Proposed Revisions to a Standard Plans Index

Originator:	Turley, Joshua	Index Number:	455-114
Date:	8/21/2024	Sheet Number(s):	2
E-mail:	Joshua.Turley@dot.state.fl.us	Index Title:	14" SQUARE CFRP & SS PRESTRESSED CONCRETE PILE

SS PRESTRESSED PILE DETAILS

STRAND PATTERN

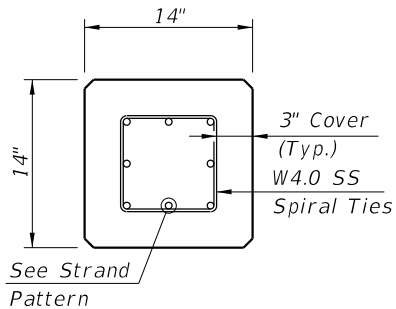
Sheet 2: Adjusted Strand Pattern diameter decimal places

This is a more accurate representation of the nominal diameter driven by the fact that the strands are fabricated in millimeters not inches.

12 ~ 0.52" Ø, HSSS at 23 kips
8 ~ 0.62" Ø, HSSS at 35 kips
